RE: 31 Hunting Lane and 41 North Main Street, Sherborn, MA

I have been retained by certain abutters and residents of Sherborn to review the above-referenced project relative to hydrologic and water quality impacts.

Figure 1 - Wastewater Contamination Plume at 31 Hunting Lane (Area of Impact)

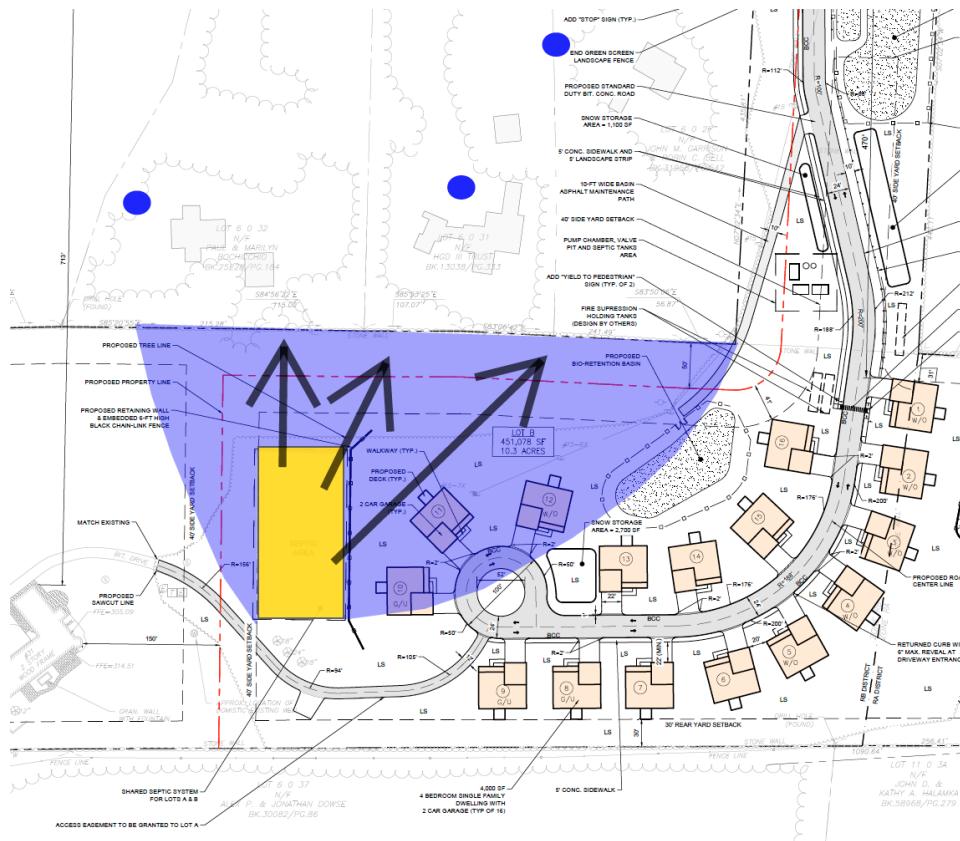
**1. The proposed wastewater discharges will cause water quality impacts to downgradient private drinking water wells.** The proposed project at 31 Hunting Lane proposes to discharge 7040 gallons/day of sewage to groundwater. The site topography and test pit data suggests that existing groundwater flow direction in the vicinity of the wastewater disposal area is northeasterly towards Hunting Lane. All of the properties in this area are served by private on-site drinking water wells. Groundwater mounding will modify these flow directions resulting in more radial flow in multiple directions and will cause the resulting plume of contamination to spread somewhat laterally as it moves downgradient.

I applied the nitrogen loading method as outlined in MADEP's "Guidelines for Title 5 Aggregation of Flows and Nitrogen Loading 310 CMR 15.216". These guidelines stipulate that for proposed wastewater flows exceeding 2000 gallons per day adjacent to areas served by private drinking water wells that nitrate-nitrogen concentrations must be maintained below 10 mg/liter at the downgradient property boundary to protect neighboring private wells.

My analysis shows an estimated area of impact downgradient of the proposed discharge location (see Figure 1). Based upon a wastewater flow rate of 7040 gallons/day, and effluent concentration of 35 mg/liter, and a groundwater recharge rate of 18 inches/year the calculated concentration of nitrate-nitrogen is 21.1 mg/liter at the downgradient property boundary. This is more than double the state and federal drinking water standard of 10 mg/liter. Several private wells (shown as blue dots) are located on the adjacent, downgradient parcels on Hunting Lane. Additionally, there may be other wells downgradient that should be evaluated.

- a) Provide water table map and groundwater flow directions for both parcels to refine the Area of Impact (AOI) and nitrogen loading analyses to determine nitrate-nitrogen concentrations at the downgradient property boundaries and downgradient private wells.

Figure 2 - Pump Test Results for Proposed Wells (Source: On-Site Engineering, October 18, 2019)

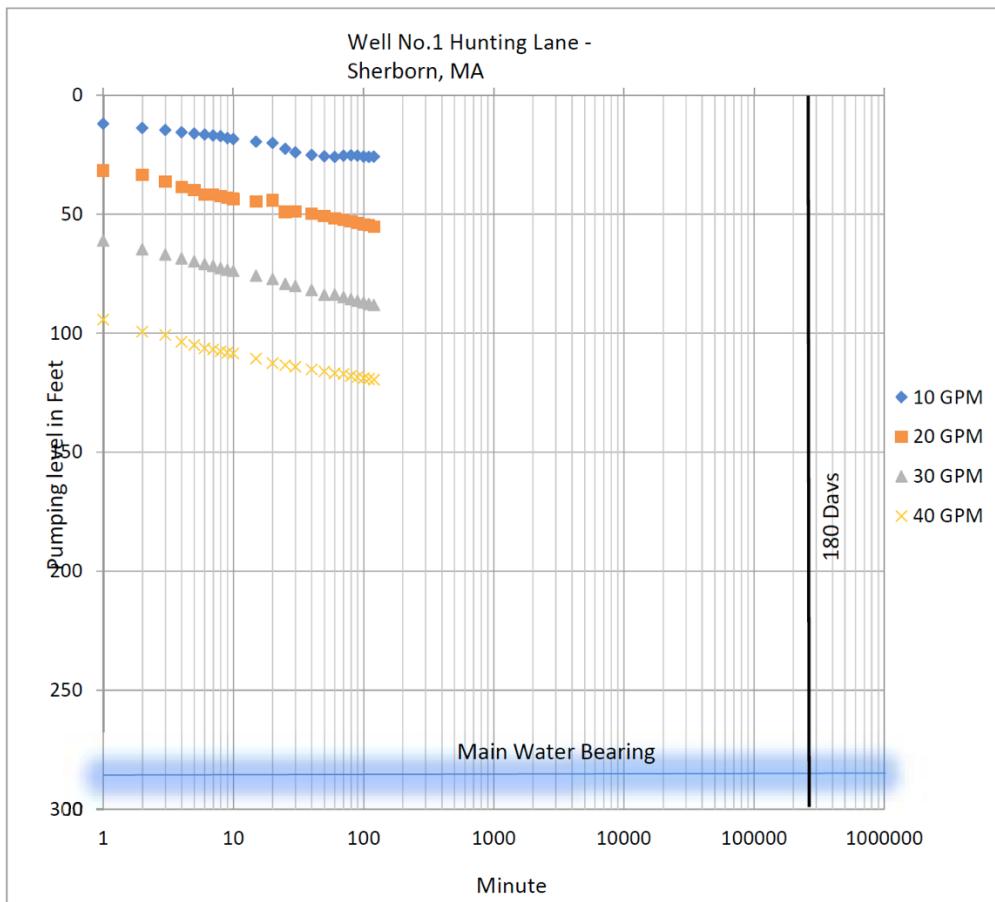
MEPA Section 11.03(3) requires an Environmental Impact Report (EIR) if the project alters more than one acre of bordering vegetated wetland, or an Environmental Notification Form (ENF) if it alters more than 5000 square feet of bordering vegetated wetland. The proposed drinking water wells are proposed to service the 31 Hunting Land and 41 North Main projects. The Applicant has conducted a pump test for these wells. It shows water table drawdowns of more than 20 feet immediately adjacent to the bordering vegetated wetland (see Figure 2). This will clearly alter more than 5000 square feet and possibly more than one acre of the wetland. Additional field and/or modeling work is required to accurately evaluate these impacts. Furthermore, I believe that the existing wetlands delineation was done more than three years ago and is therefore no longer valid. Such an analysis would be required to determine compliance with MEPA.

- c) File Environmental Notification Form (ENF) and/or Environmental Impact Report (EIR) as required by the Massachusetts Environmental Policy Act (MEPA).

Figure 3 – Groundwater Mounding beneath an infiltration area

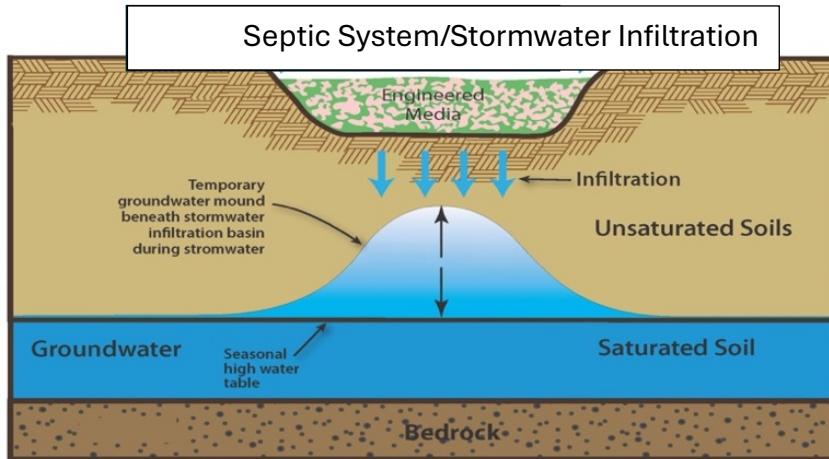
**3. Groundwater mounding will compromise the functioning of the proposed septic systems and stormwater infiltration systems.** Groundwater mounding refers to rises in the groundwater and water table caused by the subsurface infiltration of wastewater or stormwater (see figure 3). Title 5 requires a minimum separation distance of four feet (or five feet for highly permeable soils) between the bottom of the soil absorption system and the high groundwater elevation must be maintained while taking into account groundwater mounding (see excerpt below). The MADEP Stormwater Standards require a minimum vertical separation of two feet. These minimum separation distances provide important water quality functions including the filtration and attenuation of pathogens and other pollutants.

The hydrogeology of the site is characterized as low permeability soils and shallow water table. These conditions exacerbate the impacts caused by groundwater mounding. I have conducted a preliminary groundwater mounding analysis using the Hantush model<sup>1</sup>. I utilized hydraulic conductivity and specific yield values published for this area by the Massachusetts Hydrogeologic Atlas and the dimensions of the soil absorption system and saturated thickness provided by the Applicant (see Appendices to letter). The resulting analysis indicates that the groundwater mounding beneath the system will rise more than 10 feet and will inundate the wastewater soil absorption system. This groundwater mounding will also have impacts on the regulatory compliance and functioning of Title 5 septic systems on adjacent properties.

- d) Conduct groundwater mounding analyses for the proposed wastewater discharge areas and stormwater infiltration systems. This analysis should include cumulative impacts of these facilities and should identify any off-site groundwater level changes that may cause compliance issues with existing Title 5 systems.
